**FINAL ALTERNATIVES ASSESSMENT
OF
INTERIM RESPONSE ACTIONS
FOR
OTHER CONTAMINATION SOURCES
MOTOR POOL AREA
NOVEMBER 1989
CONTRACT NO. DAAA15-88-D-0022/0002
VERSION 3.1**

WOODWARD-CLYDE CONSULTANTS

**U.S. ARMY PROGRAM MANAGER'S OFFICE
FOR ROCKY MOUNTAIN ARSENAL CONTAMINATION CLEANUP**

Re: Rocky Mountain Arsenal (RMA)
Alternative Assessment of Interim
Response Actions for Other
Contamination Sources: Motor
Pool Area, September 1989.

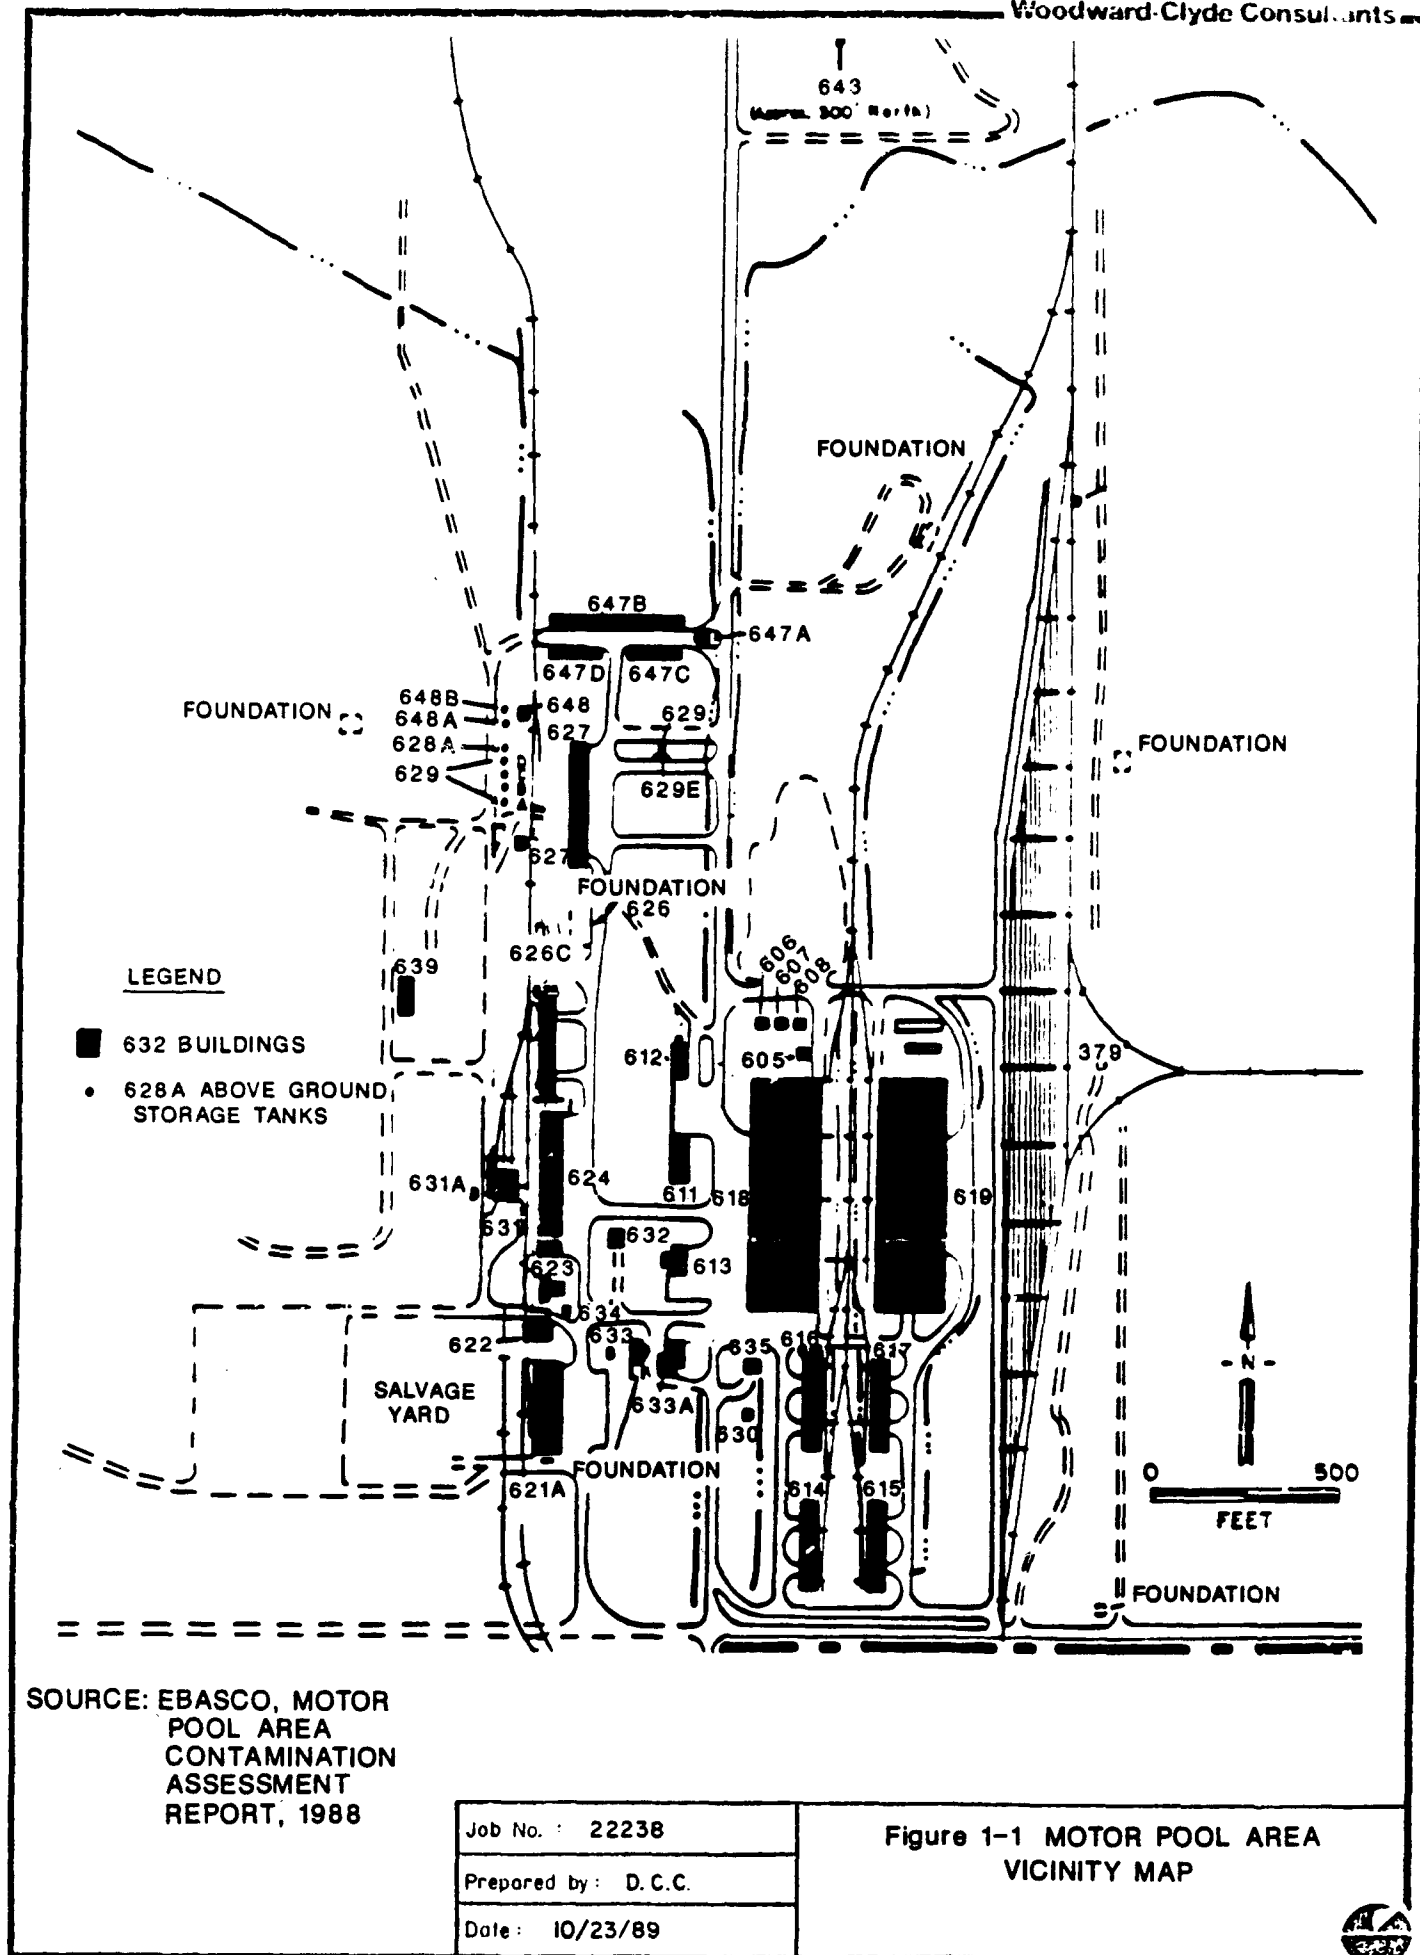
Comment 2: Figure 1-1 - The legend for this figure is not clear and should therefore be corrected.

**Figure 1-2 - DECISION FLOW CHART FOR
INTERIM ACTION VERSUS
MONITORING/MAINTENANCE
ON HOT SPOT IRAs**

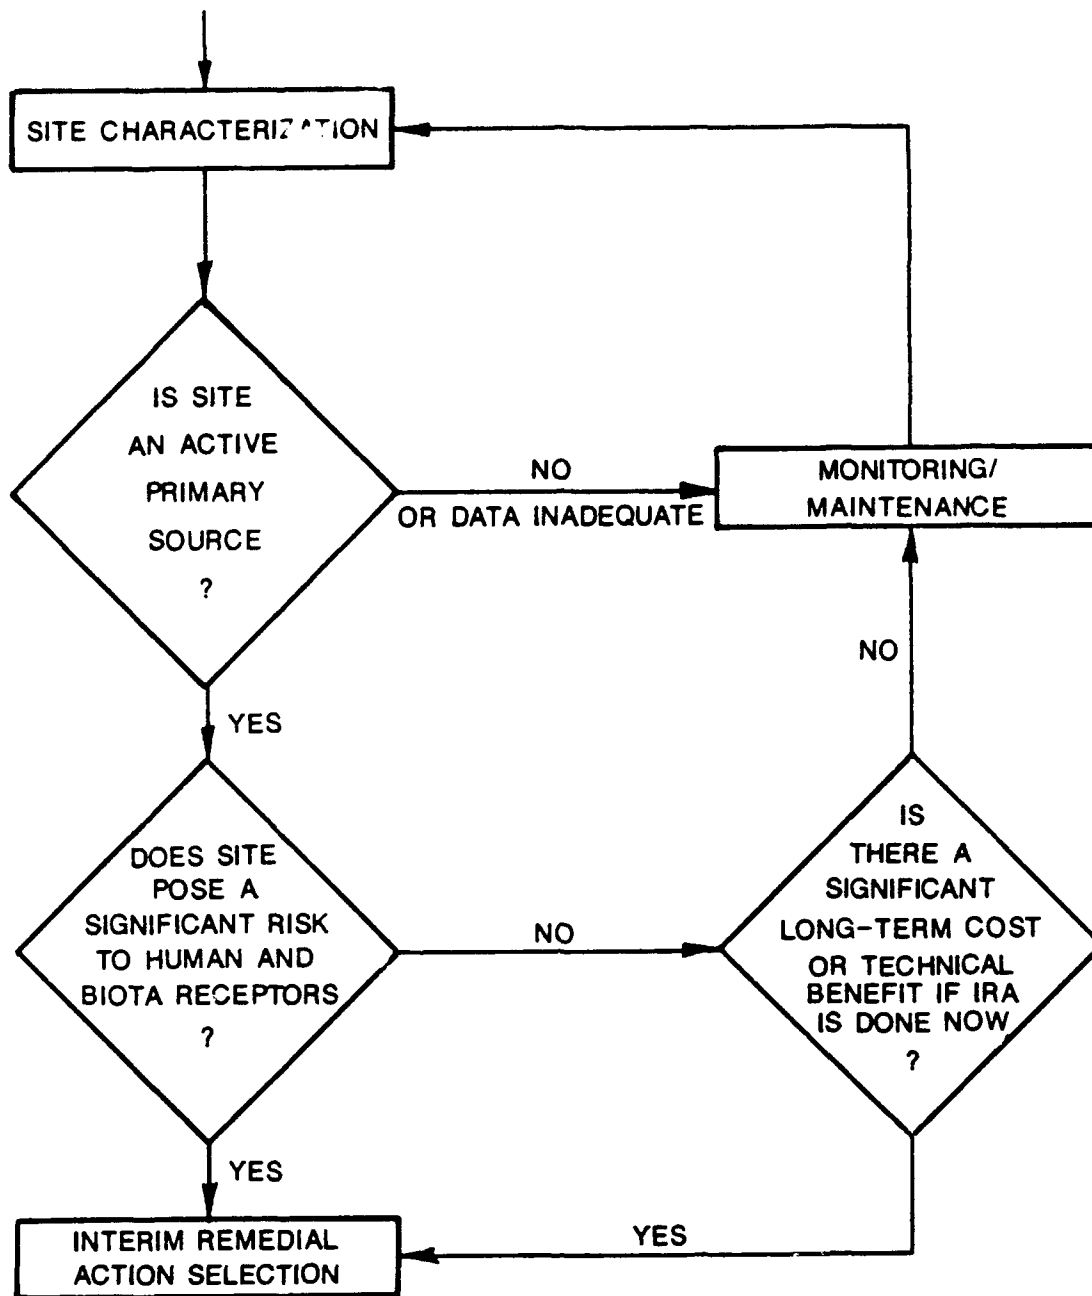
Comment 3: Page 1-3 & 1-4 - The candidate selection criteria discussed on pages 1-3 and 1-4 do not accord with the flow chart presented as Figure 1-2. Specifically, the flow chart's initial diamond which presents the threshold question of whether the site is an active, primary source of contamination does not limit that question to an assessment of the site's effect on ground water. Such a limitation was expressly disapproved by State representatives at the June 7, 1989 subcommittee meeting which was held to discuss screening criteria for the "other sources" IRA.

Comment 3: The Decision Flow Chart presented in this assessment (Figure 1-2) is an altered version of the Flow Chart actually agreed to by the Organizations and the State at the June 7, 1989 Other Contamination Sources Subcommittee meeting. Specifically, Data Inadequate should be on the NO leg of the first decision node, not on the YES node. The version agreed to is shown in Figure 1-1 of the final Technical Plan.

**Figure 2-1 WATER TABLE ELEVATIONS,
GENERALIZED GROUND WATER FLOW
DIRECTION, AND WELL LOCATIONS**

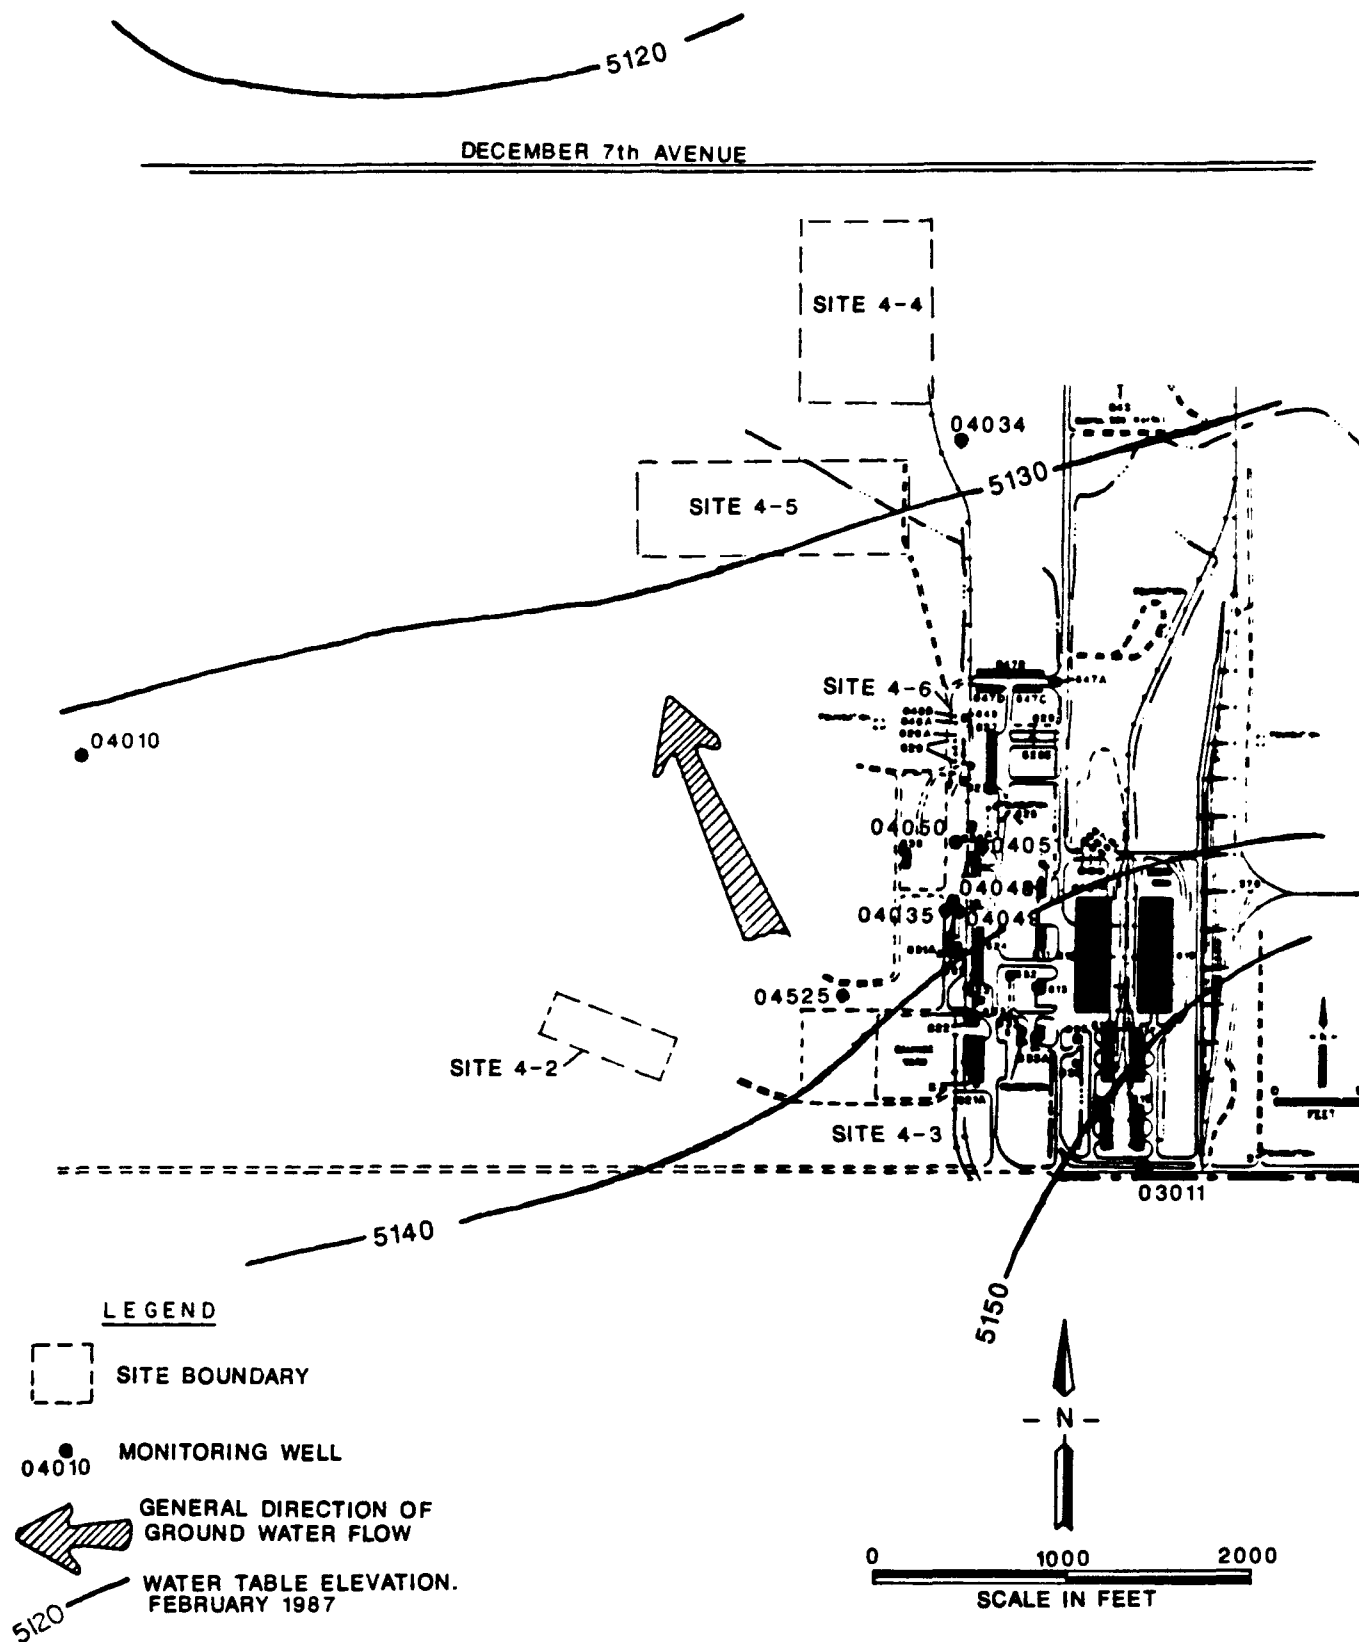
Should the reference (Table 2-2) be (Figure 2-1) instead? Table 2-2 does not identify water quality by wells, but Figure 2-1 shows well locations but no water quality data. It would be helpful if a TCE plume map were provided in this Section.

**FIGURE 2-2 TCE SOIL GAS
SURVEY MOTOR POOL AREA**

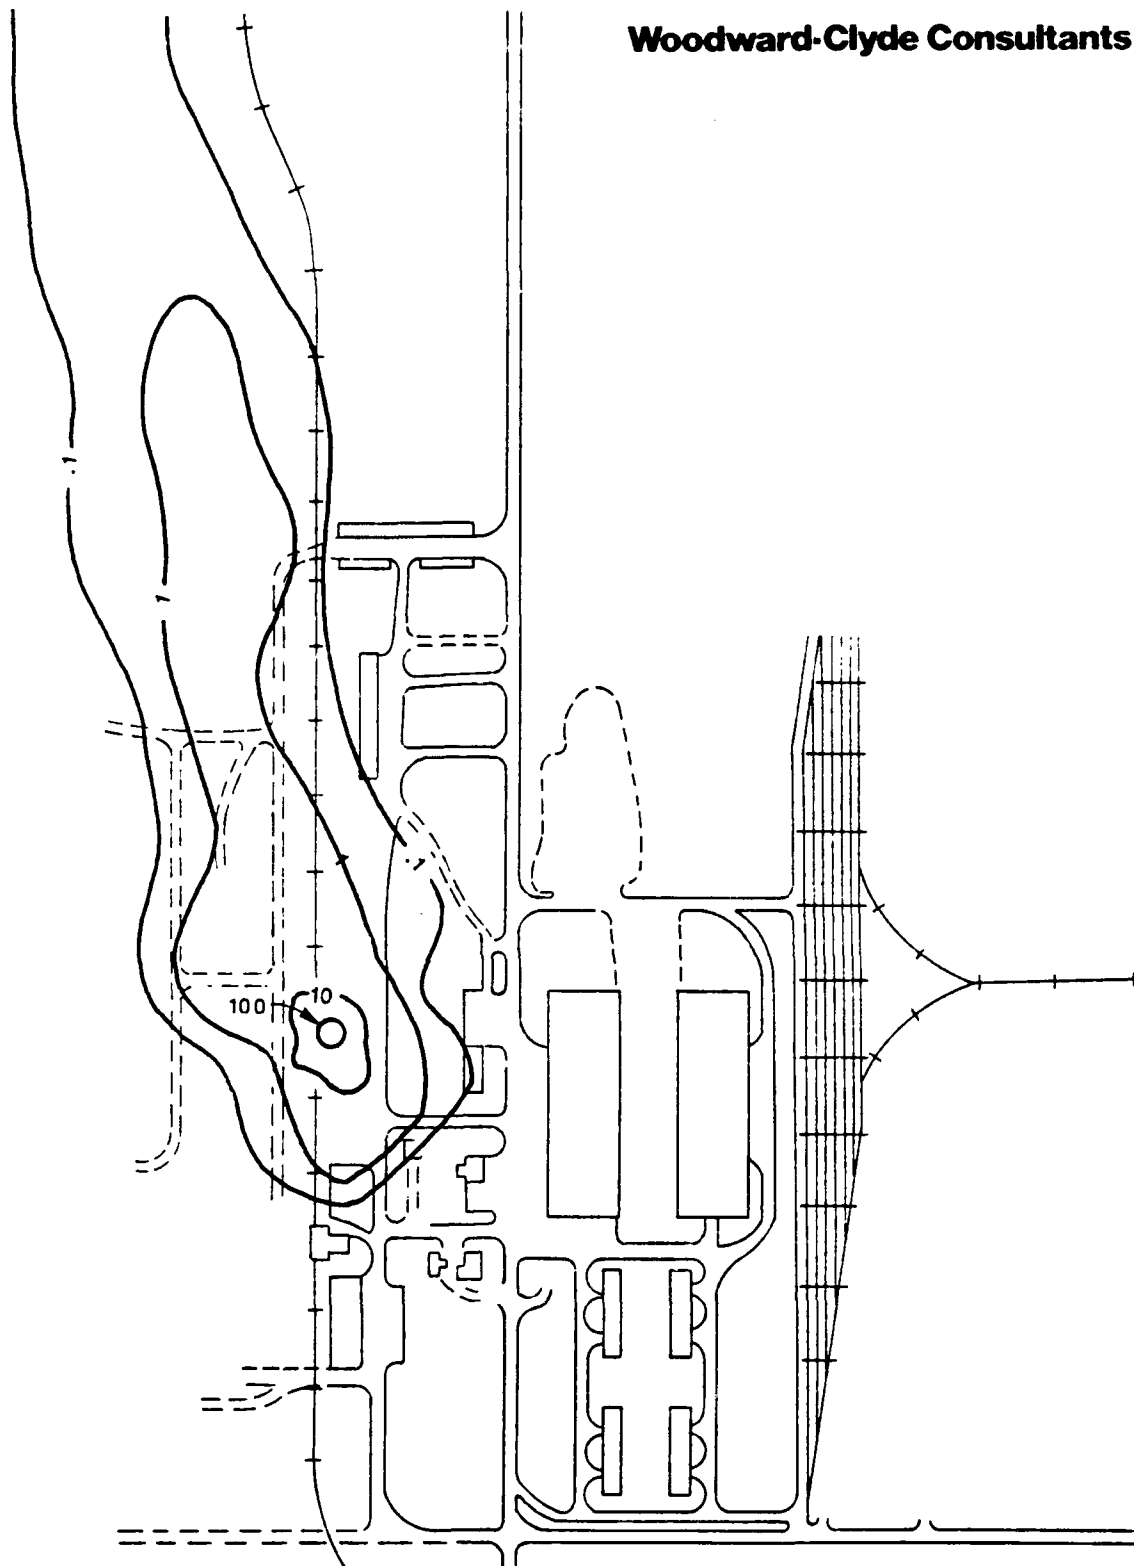
The standard soil gas sampling depth is stated as 15 feet in the text but appears to be 5 feet on Figure 2-2. Which is correct? Figure 2-2 is very difficult to read and the locations of the buildings should be made clear. Also, soil gas concentrations are not shown for many of the 5-foot sample locations.

No data are presented to substantiate this statement. Maximum sampling depth in the 1989 soil gas sampling program was described as 15 feet, although Figure 2-2 shows one sample point at 20 feet at location G5. No significant attenuation of the TCE concentration occurred at this depth.

Response: Figure 2-2 has been revised to provide a better summary of results for the purposes of this document. The standard sampling depth was 15 feet -- the figure was incorrect. Details of the investigation and results can be found in the Field and Laboratory Investigation Report (WCC 1989).
